KARACHI MUNICIPALITY.

Permission granted to Mr. Tayabali Allibhoy Jiwanji to erect a house
on Plot No. 88/A, 88/B and 107, B-21, Serai Quarter.

PLAN SHOWING PROPOSED
BUILDING ON
PLOTS Nos 88A 88B & 107 SHEET B.21
SERAI QR
SCALE 1/4" = 1'

With reference to ^{his}~~their~~ application dated 5th instant with a plan for the proposal ^{Building}~~additional~~ on plot No. 88, 88, 107 Survey Sheet No. B-21 Serai Quarter Mr. Mussainbhay Alideelali is informed that until the following requirements are complied with the plans cannot be passed.

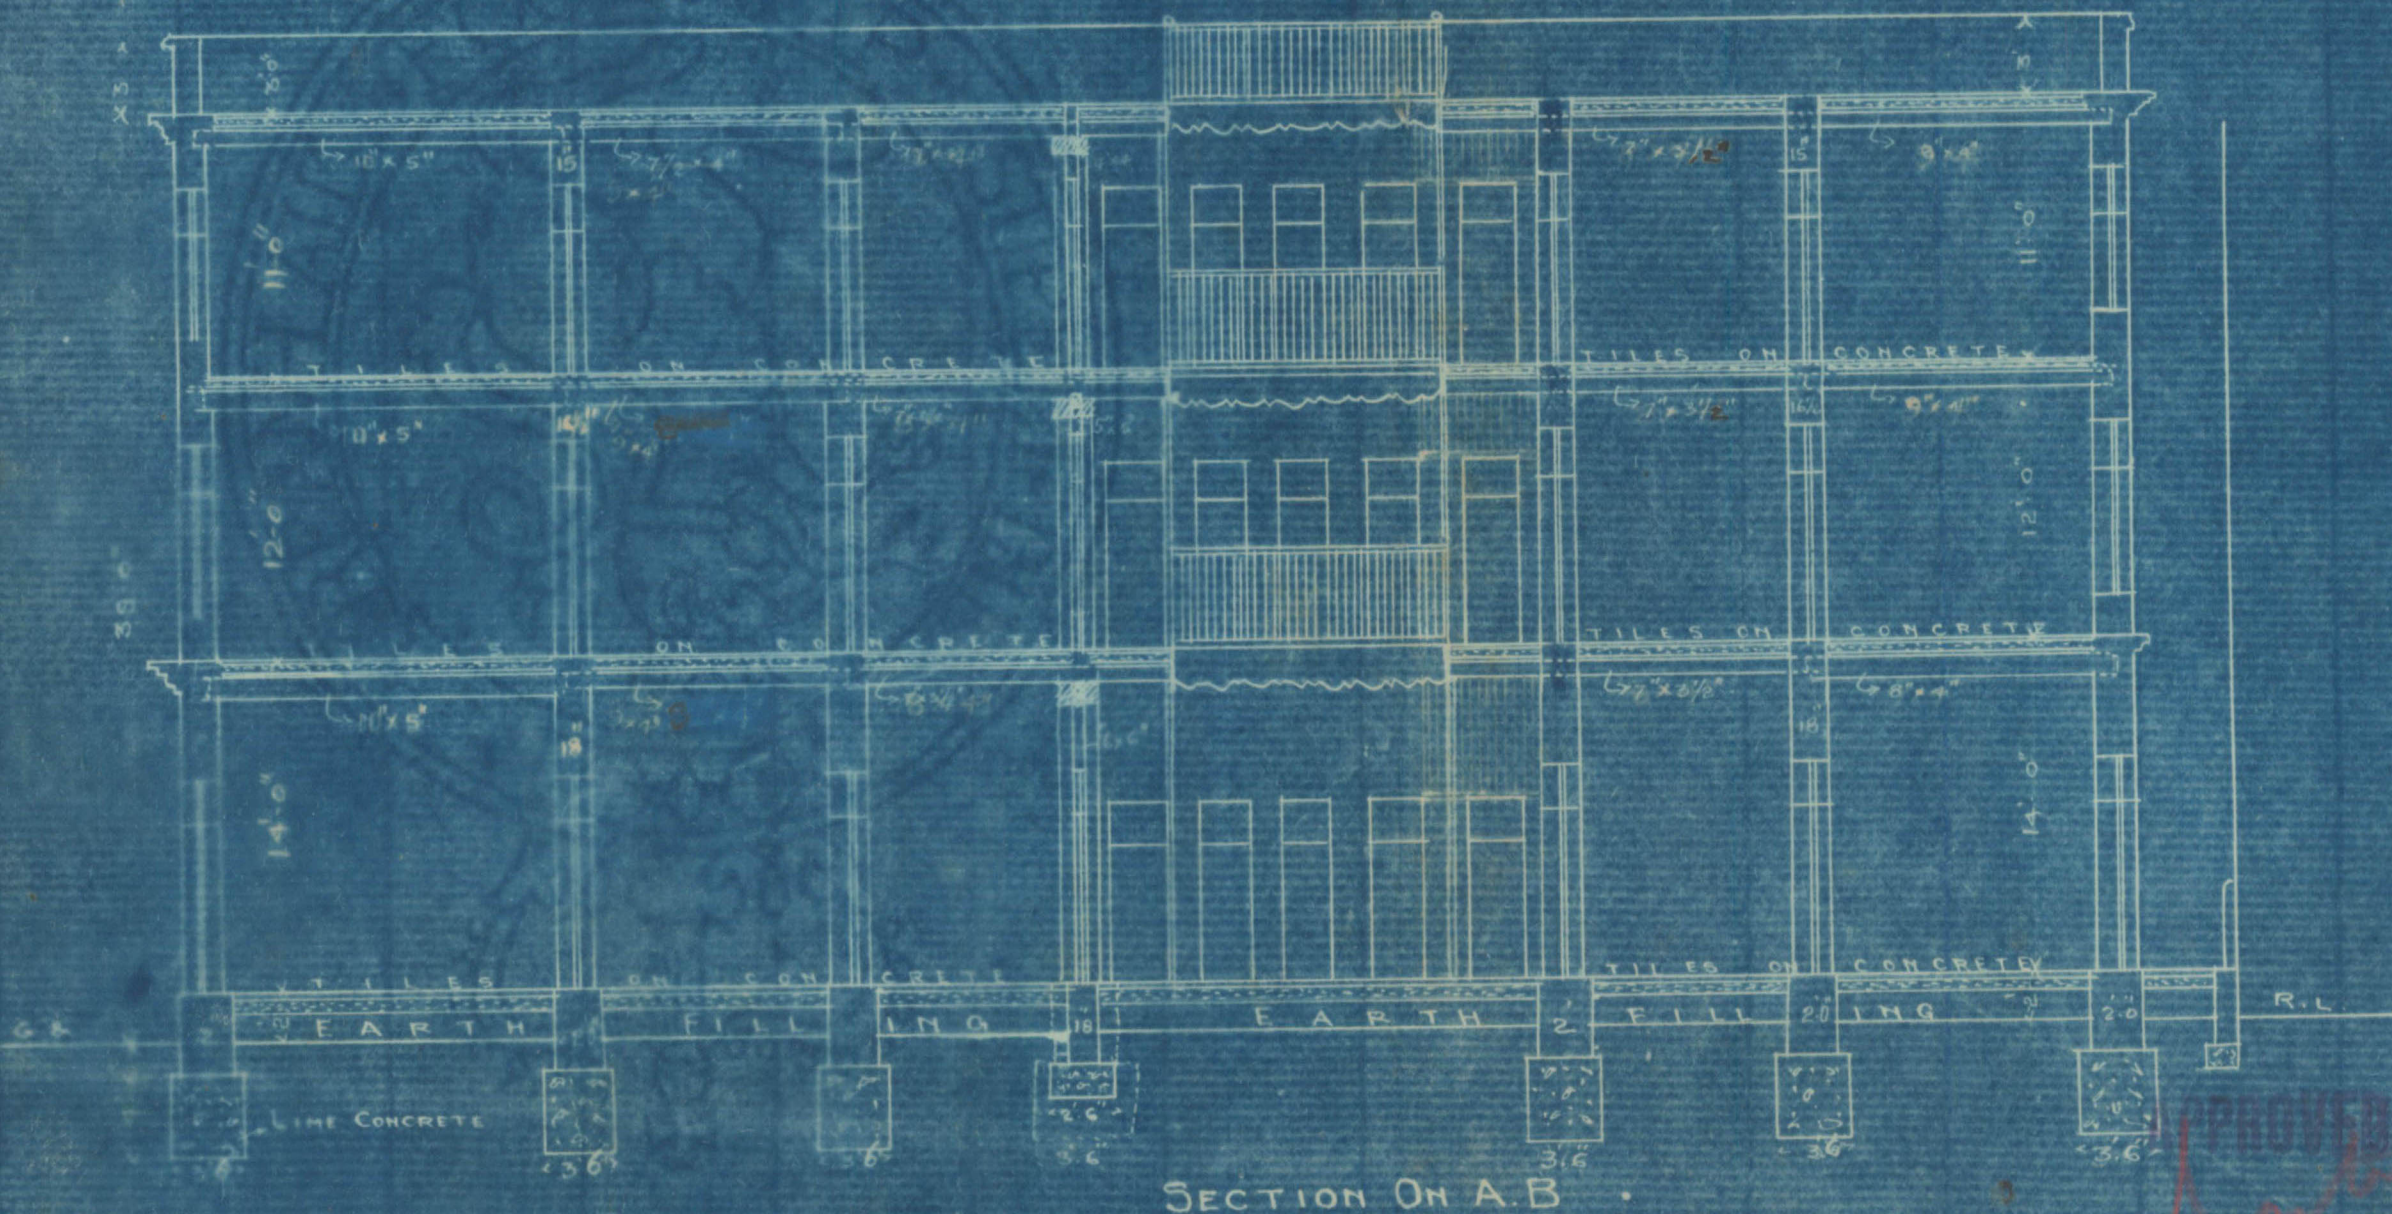
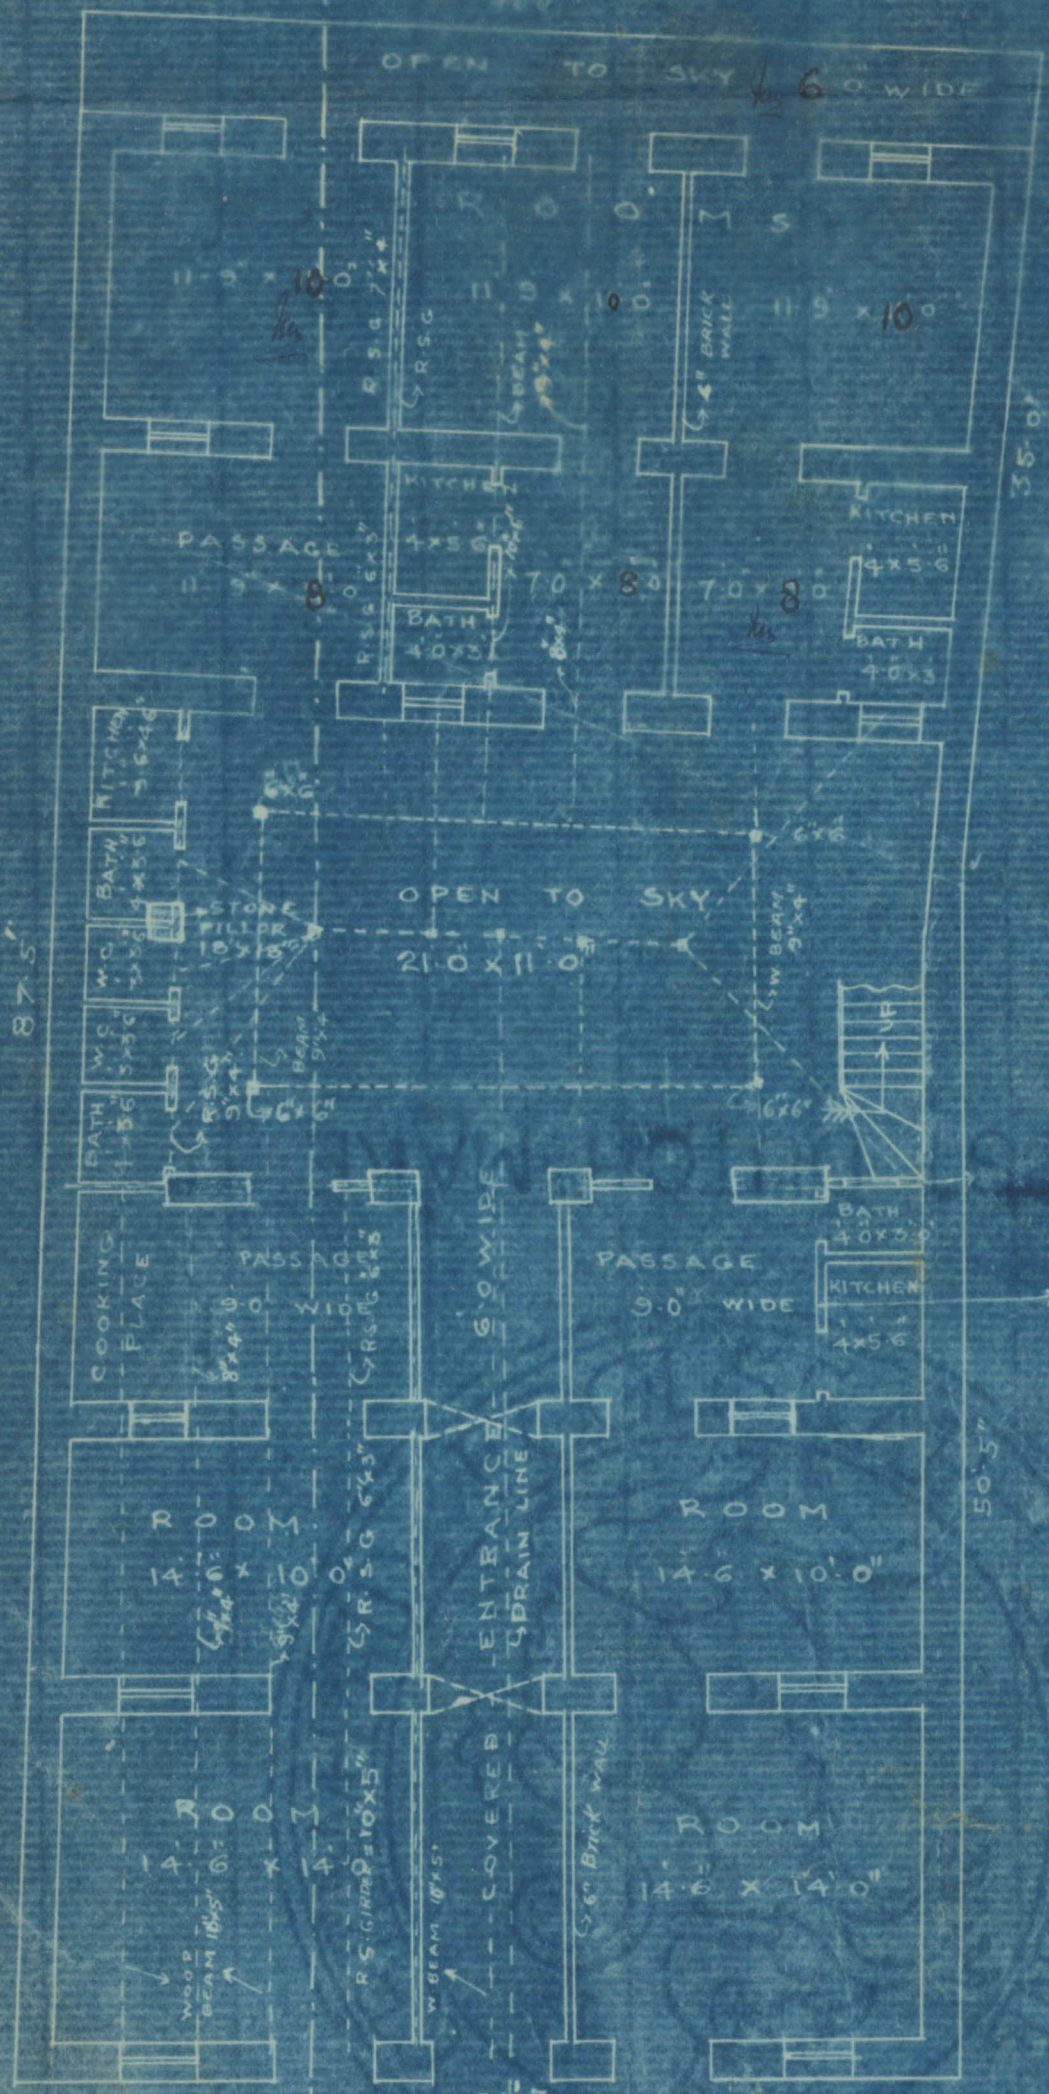
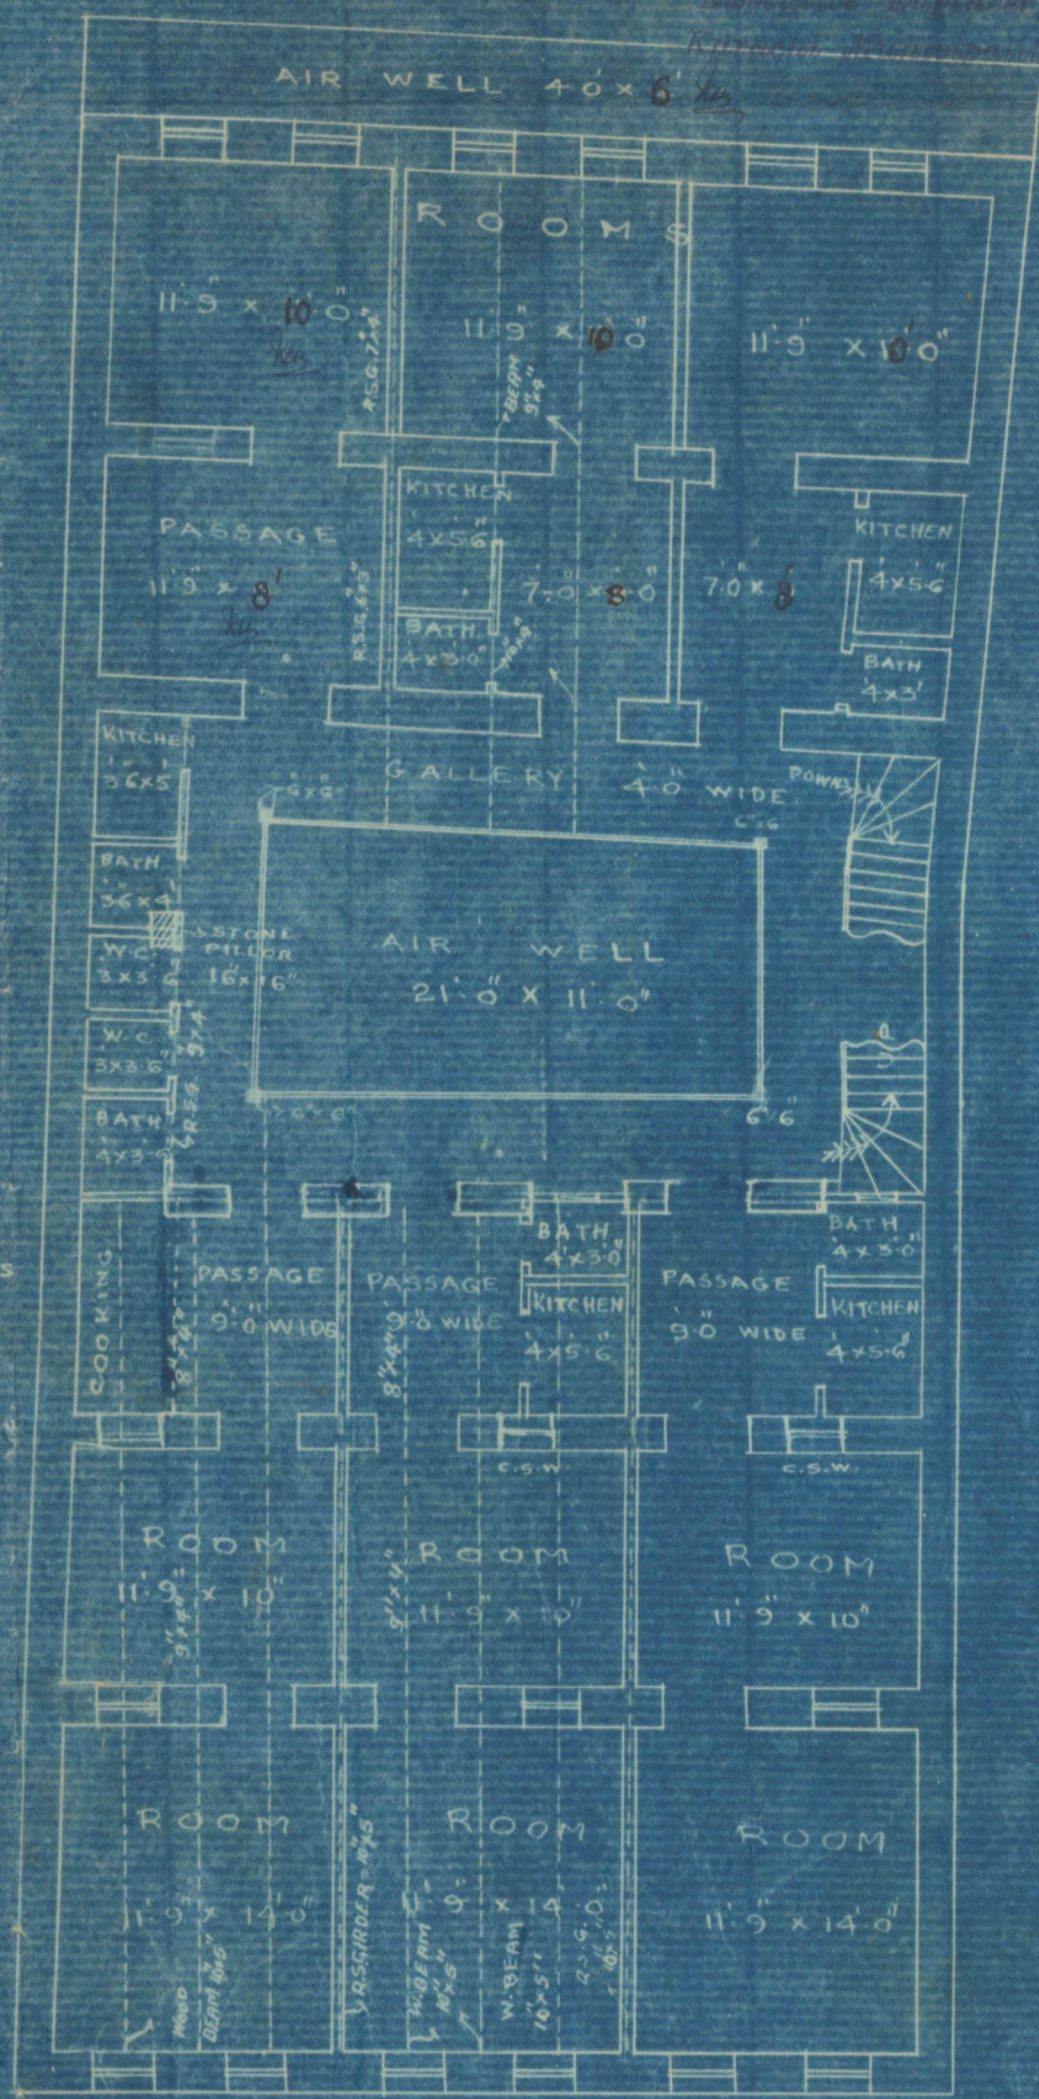
Sent for the Architect &

ask him to initial

the correction in the

width of the clerestory

space & remove

- (1) Outer wall of passage should be built pucca.
- (2) 12x7 beam should be provided below p. wall (14' plan)
- (3) 16x9 beam must be provided below p. wall of bath + w.c.
- (4) Middle room will be dark, windows should be provided with ventilators.
- (5) Width of road should be given.
- (6) Width of foundation should be increased to 3' 6"
- (7) Kitchen walls should be 7' high & the ^{above} portion to be ^{grated}
- (8) Arrangement of joints should be shown on plan
- (9) Posts must be provided as shown on one of the blue print.

1. outer wall of passage is now made pacca.
2. R.S.B. 10"x5" is provided below partition wall 14' long
3. R.S.B. 9"x4" is provided below partition walls of out houses with a stone pillar 18"x18" in the middle.
4. Clerestory windows above 7' height are provided for ventilating the middle rooms.
5. width of road is now given.
6. width of foundation is now increased to 3'6"
7. a note is made in the plan stating that the Kitchen wall is 7'0 high with the upper portion grated.

8. arrangements of joists have been shown on plans of ground and upper floors.

9. Since the outer wall is made pacca, the necessity of providing posts disappears.
